STAFF RECOMMENDATION

808 Shelby Avenue
March 20, 2019

Application: New Construction—Addition; Setback Determination
District: Edgefield Historic Preservation Zoning Overlay
Council District: 06
Map and Parcel Number: 082160X00100CO & 082160X00200CO
Applicant: Jeff Checko
Project Lead: Melissa Sajid, melissa.sajid@nashville.gov

Description of Project: Application is to construct deck additions to both side façades, and to reduce both side setbacks from five feet (5') to three feet (3').

Figure 1: Infill at 808 Shelby Avenue

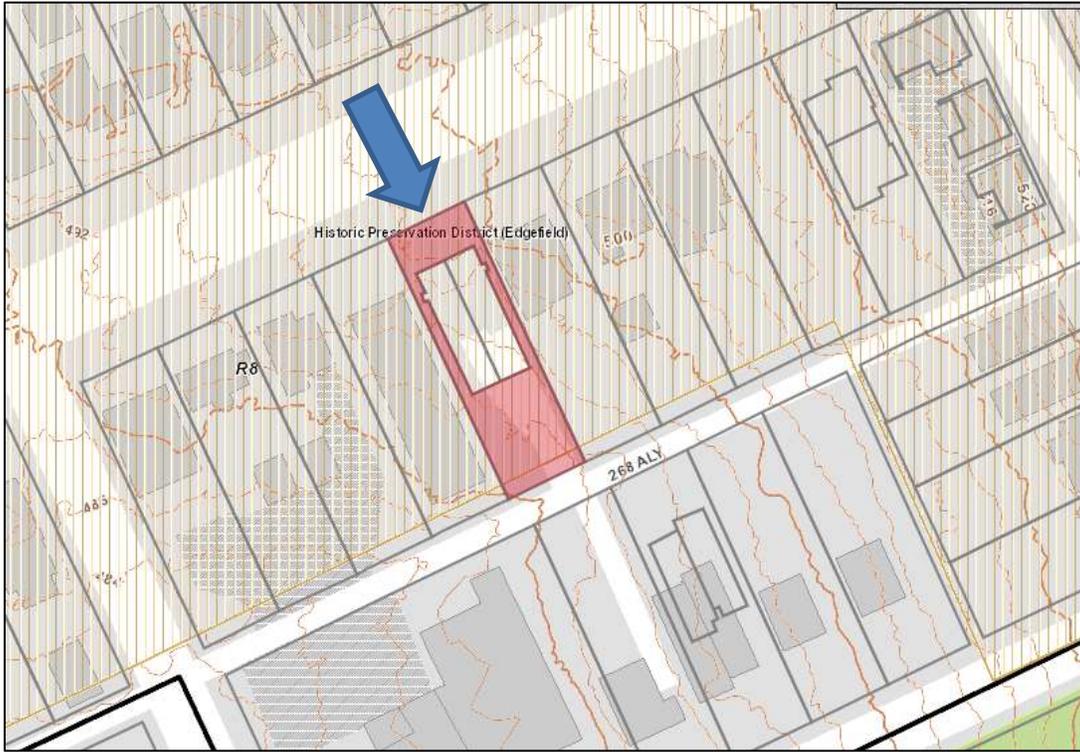
Background: The applicant proposes side additions to an infill duplex that MHZC approved in 2017 (Figure 1). The request includes setback determinations to reduce both side setbacks from five feet (5') to three feet (3'). Staff administratively approved a carport outbuilding (HCP 2019010544) as well as second level uncovered deck on the rear and uncovered exterior stairs from the side doors to grade (HCP 2019006685) in February 2019. The proposed addition would connect the side stairs to the rear deck.

Figure 2: Exterior stairs and rear deck approved administratively by staff in February 2019

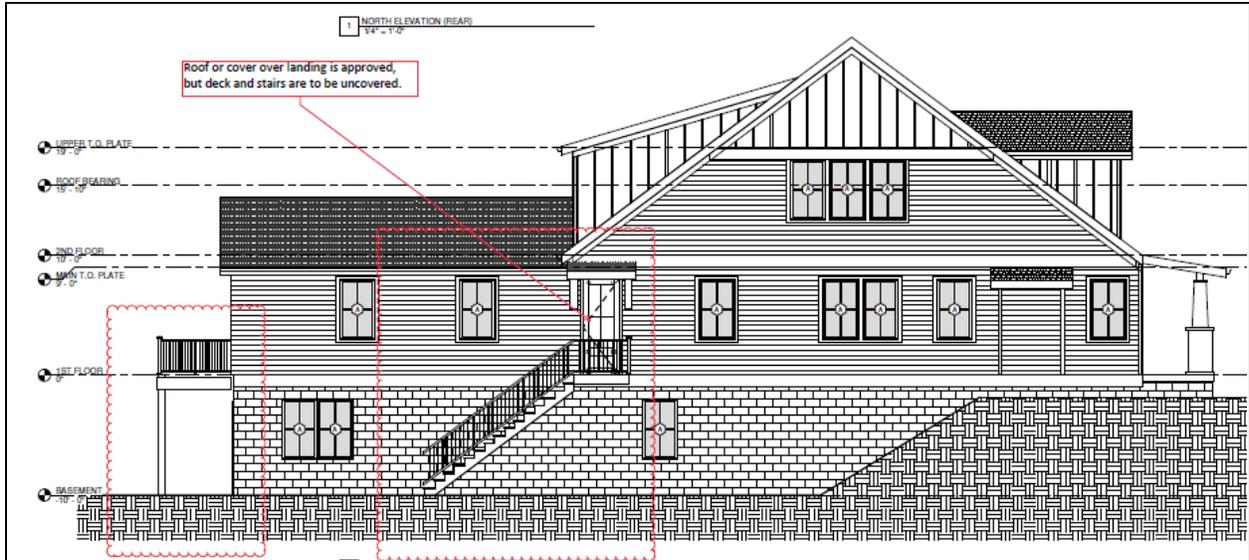
Setback & Rhythm of Spacing: The proposed decks will be located three feet (3') from the side property lines. The Zoning Code requires a minimum side setback of five feet (5') and allows for certain elements to encroach into the side setback such as chimneys, porch coverings, eaves, gutters, and uncovered stairs or fire escapes. Staff administratively approved a stoop covering and uncovered stairs from the side doors in February 2019 (Figures 2 & 3).

The proposed addition would connect the side entrance to the rear deck. At that point, the Zoning Code considers the proposed addition an uncovered deck, which is not permitted to encroach into the minimum five feet (5') side setback. As proposed the addition would be three feet (3') from both side property lines and would need a setback determination to reduce both side setbacks from five feet (5') to three feet (3'). Setback determinations take into account historic conditions; however, this proposal does not meet any of those conditions where setbacks less than those required by the bulk standards have been found appropriate for the historic context.

Staff finds that the project does not meet Section III.B.2.a.

FRONT ELEVATION

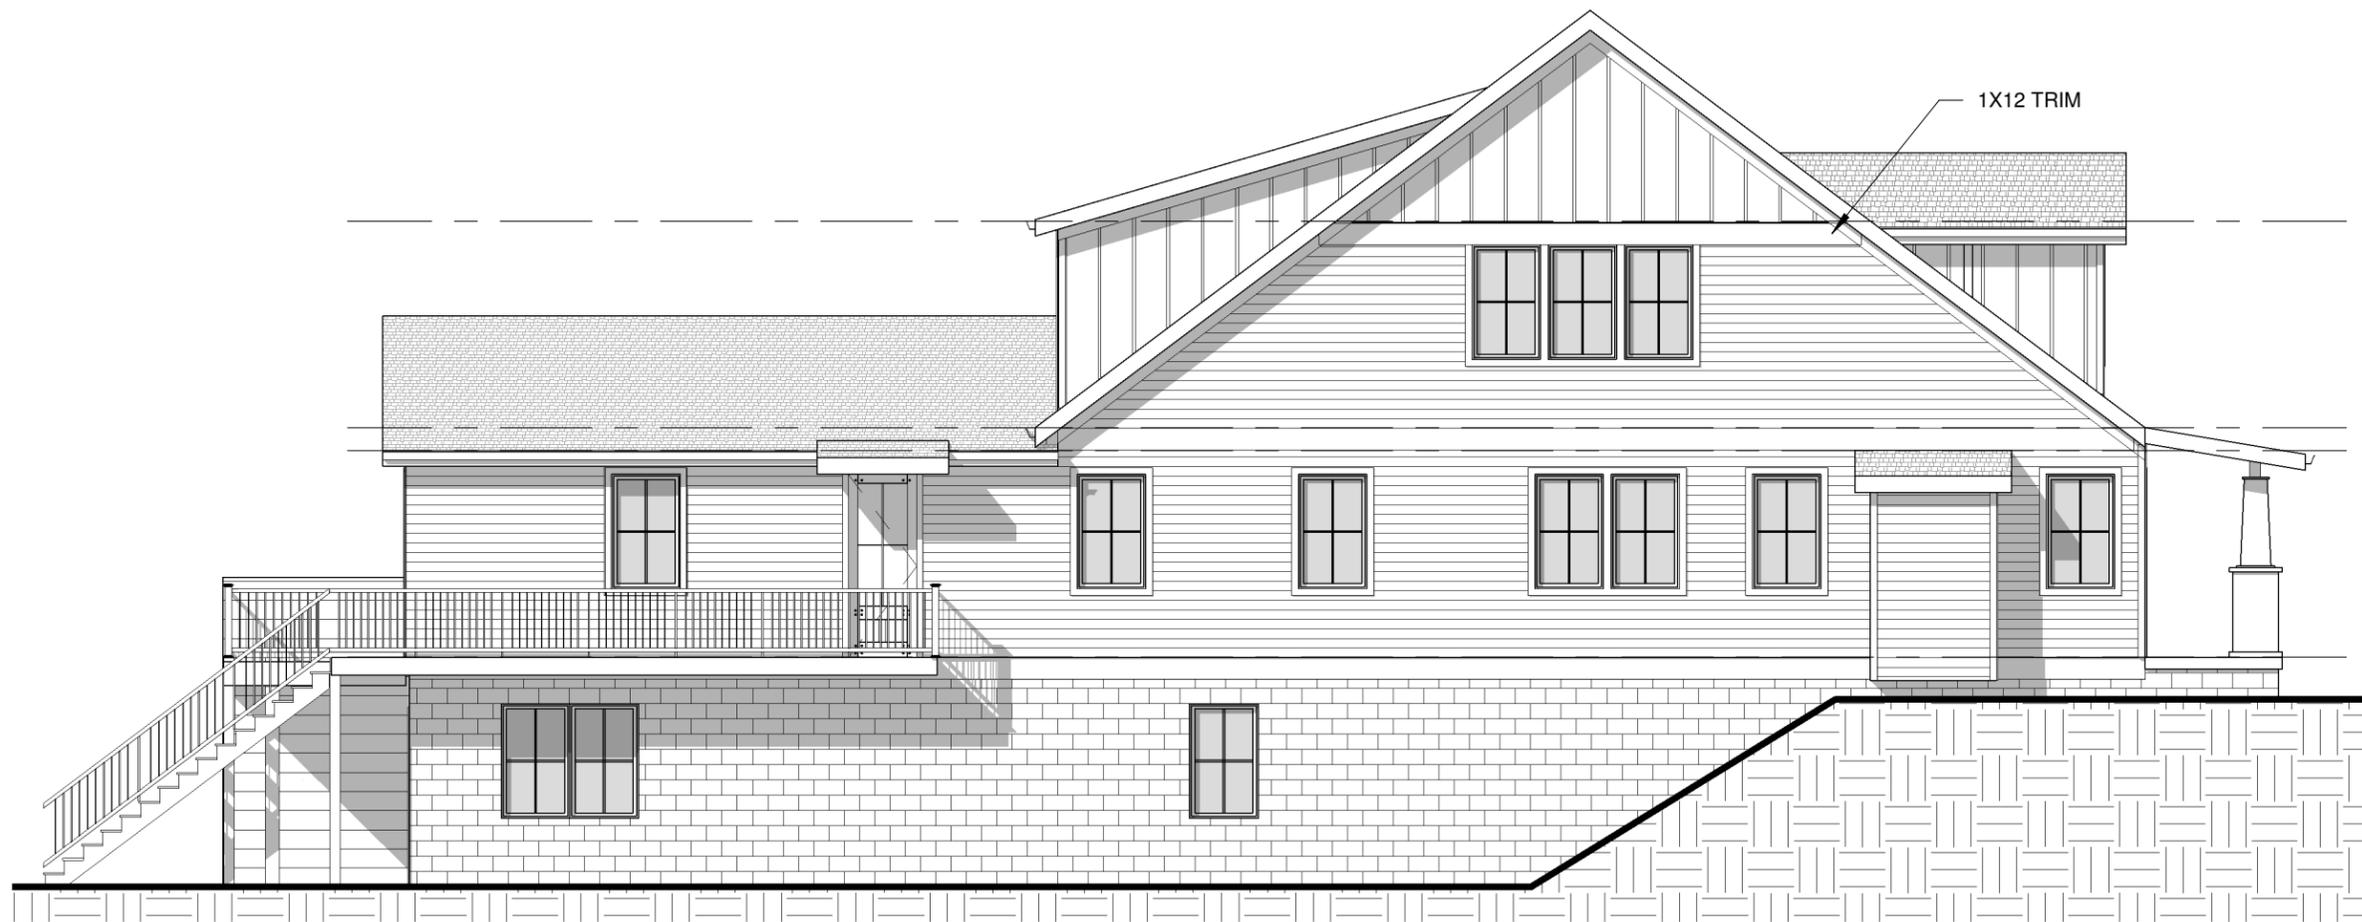
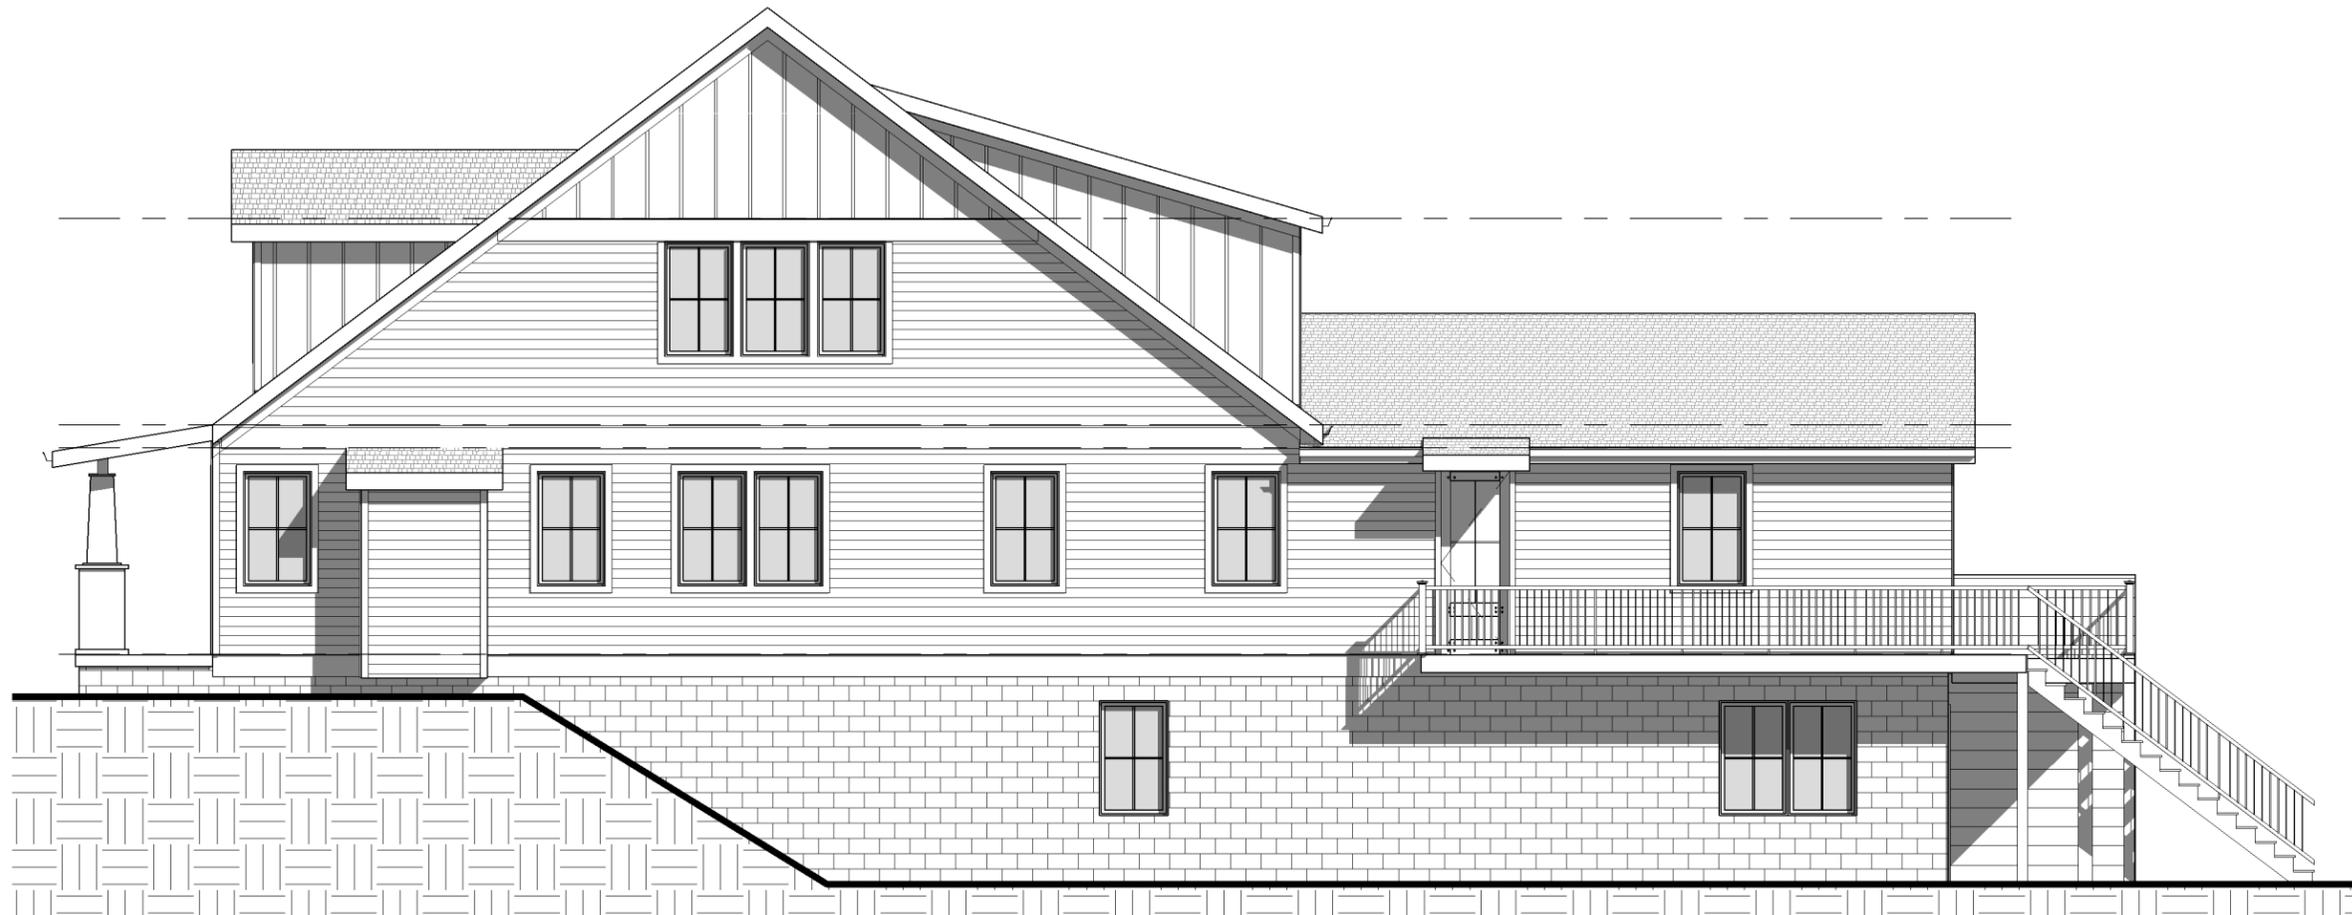
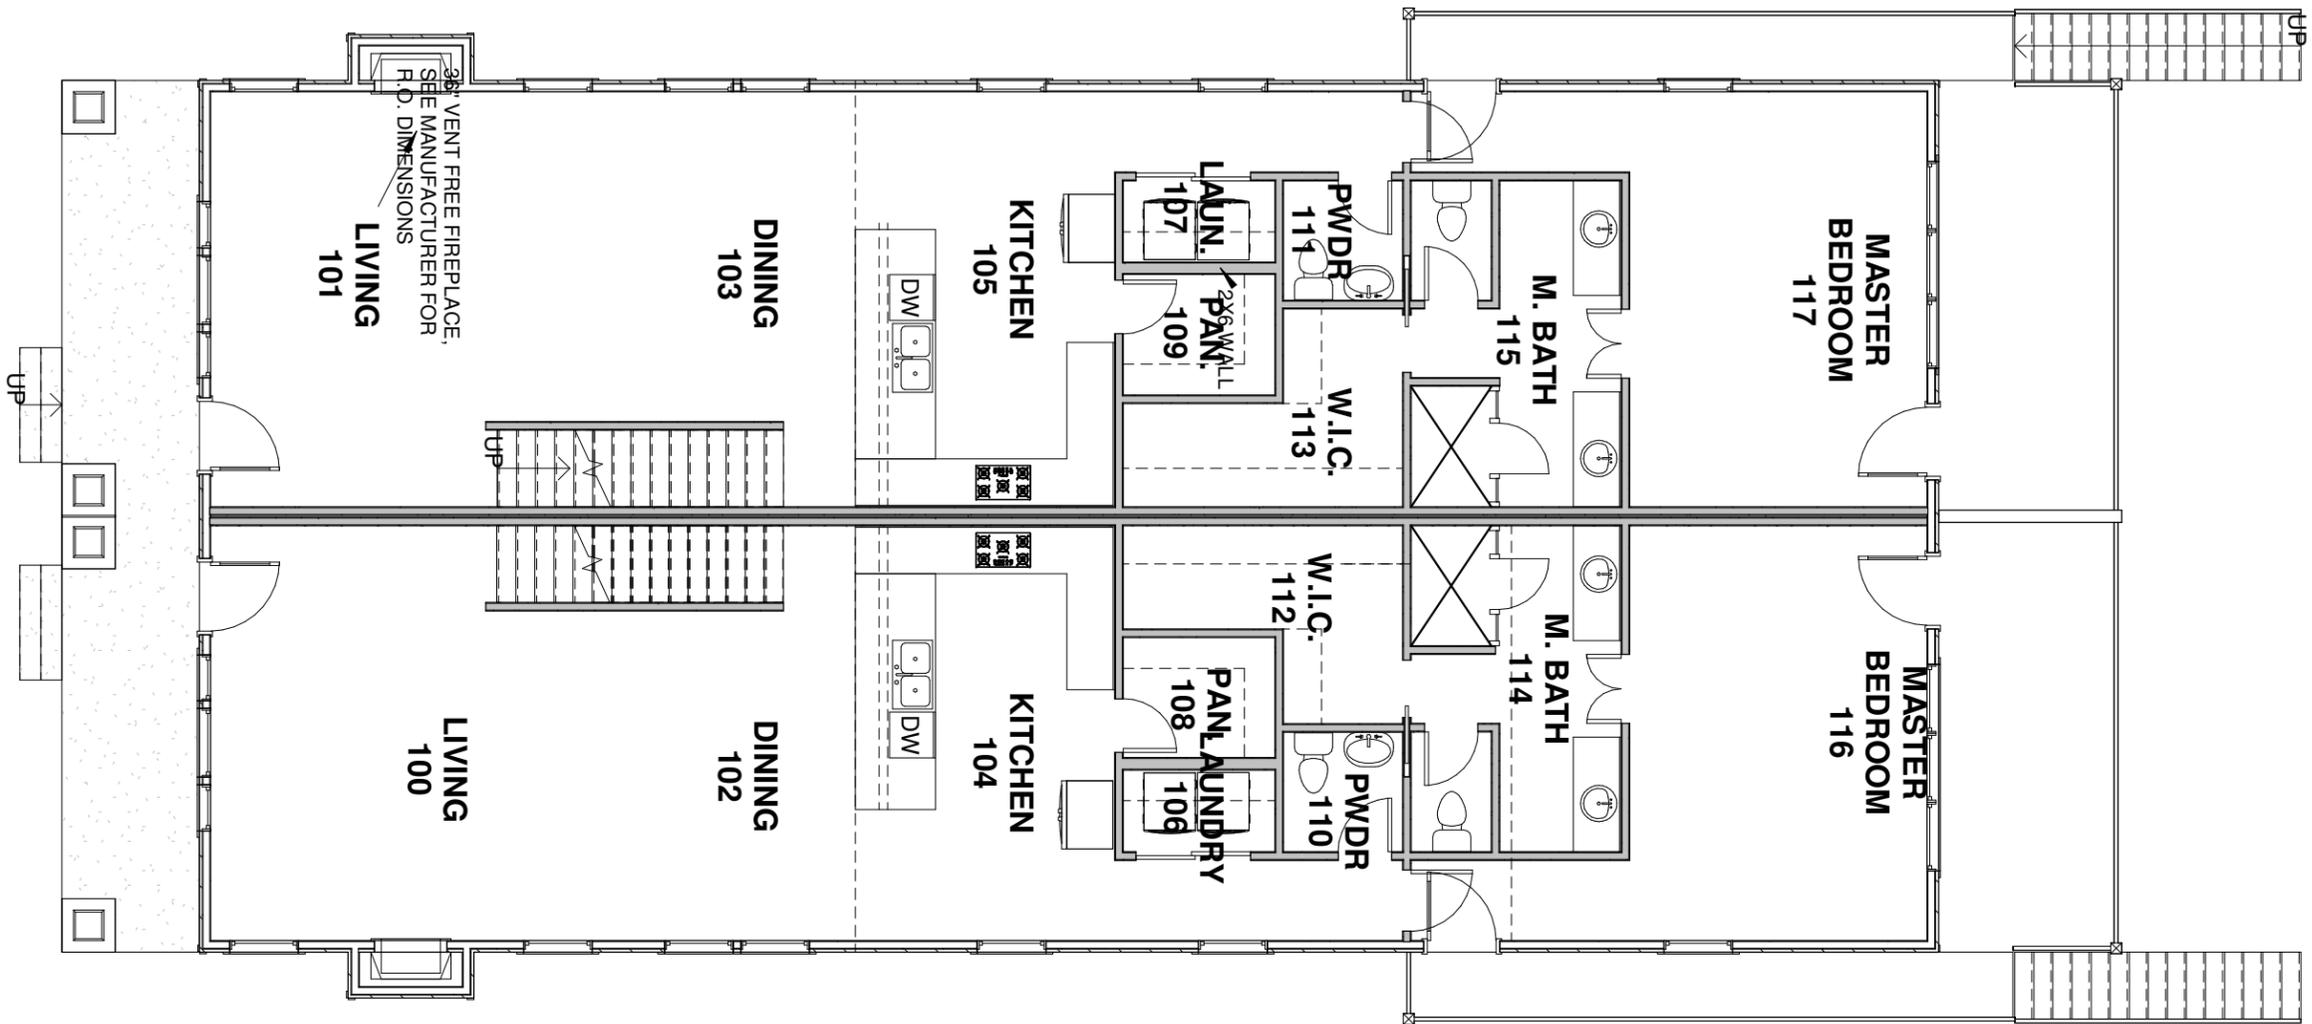
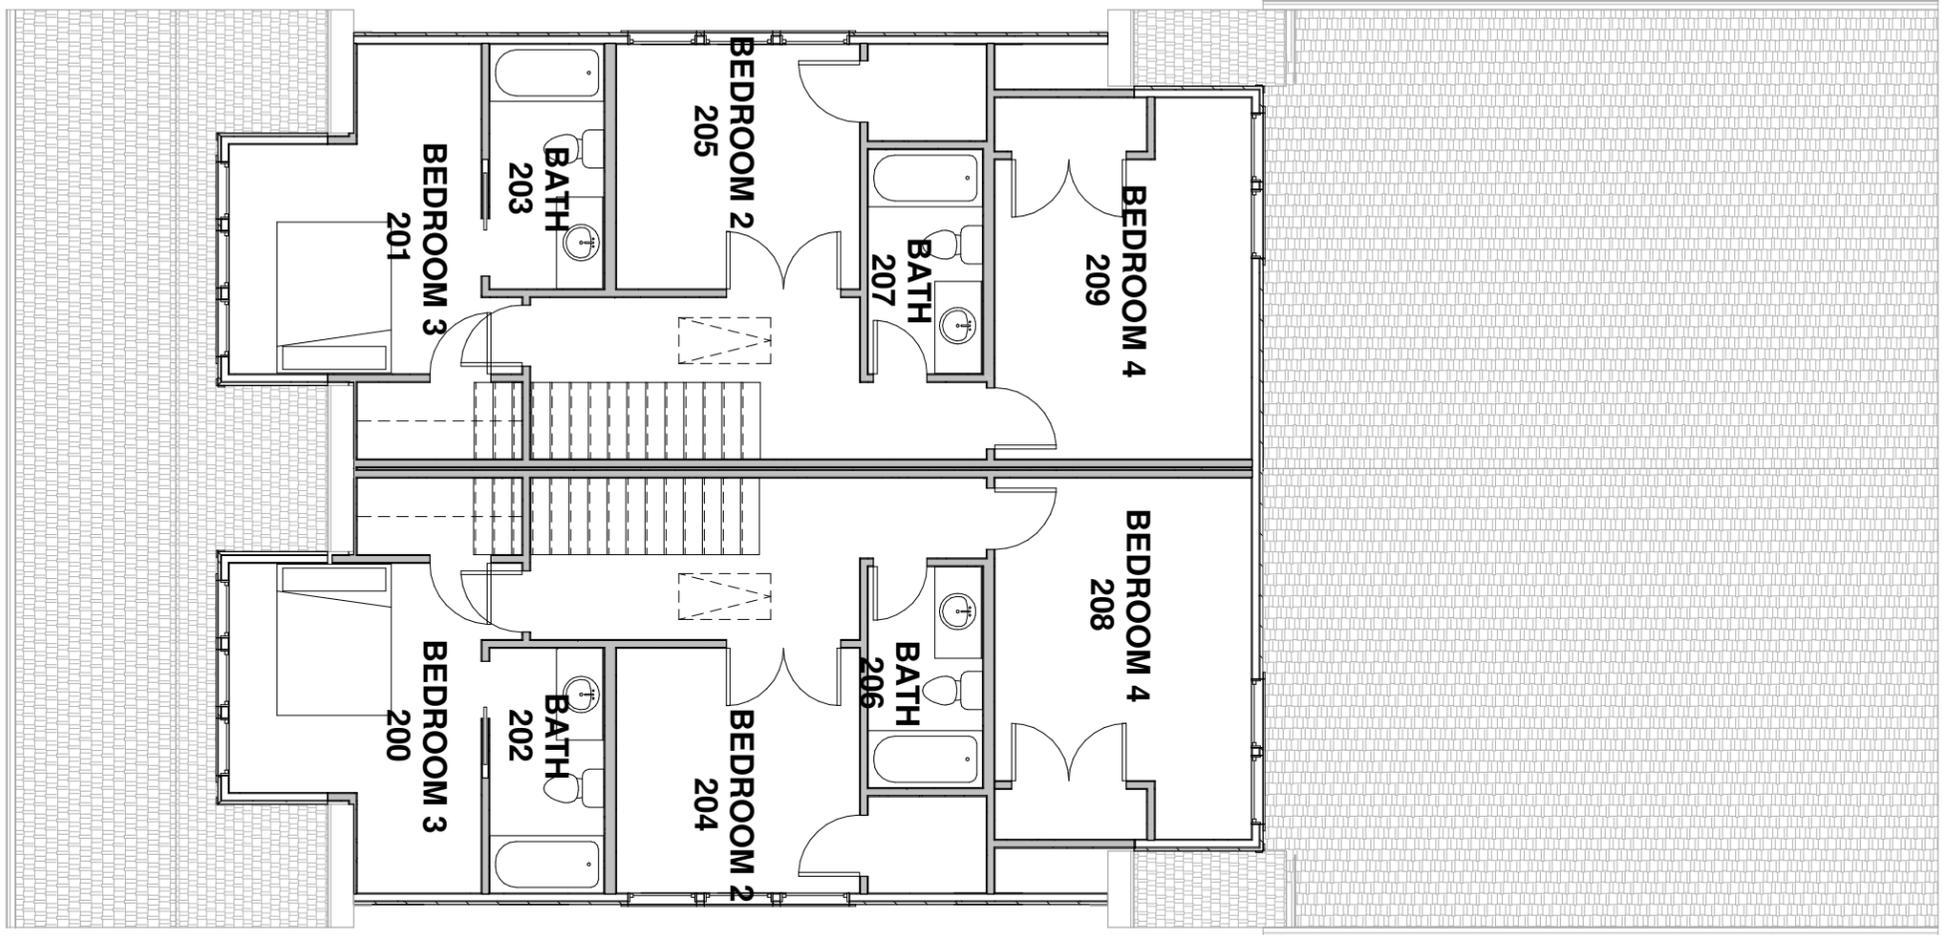
Height & Scale: The addition does not add additional height to the infill but will add an additional four feet (4') to the width and approximately seventy-two square feet (72 sq. ft.) to the footprint. The infill was approved with the minimum side setbacks permitted for the base zoning. Staff finds that increasing the width will further increase the scale of an infill that was already approved on the high end of the historic context for width.

Design, Location & Removability: The addition is located on both sides of the house. The decks start approximately thirty-five feet (35') behind the front wall, extend two feet (2') wider than the house, and extend beyond the rear wall.

The design guidelines state that additions should be located at the rear of the house. Side additions may be appropriate when the width of the lot exceeds sixty feet (60') or the standard width on the block. The subject property does not meet the criteria for side additions as the lot is only fifty feet (50') wide, which is the typical lot width on this block of Shelby Avenue. The project does not meet Section III.B.1.

Materials: While the material to be used for the decking is not labeled on the plans, it would likely be constructed of wood. Wood is typically an appropriate material for a deck if it were located at the rear. However, staff finds that the materials are not visually compatible on a potentially public façade as decking materials are generally not seen from the street. Exterior stairs using the same material were previously approved by staff to provide egress from the side doors as they met all design guidelines and bulk standards of the Zoning Code.

Recommendation: Staff recommends disapproval of the proposed side deck additions and the requested setback determinations, finding that the project does not meet Sections III.B.1 (Additions), III.B.2.a (Setback and Rhythm of Spacing), and III.B.2.g (Materials) of the Edgefield Historic Preservation Zoning Overlay design guidelines.
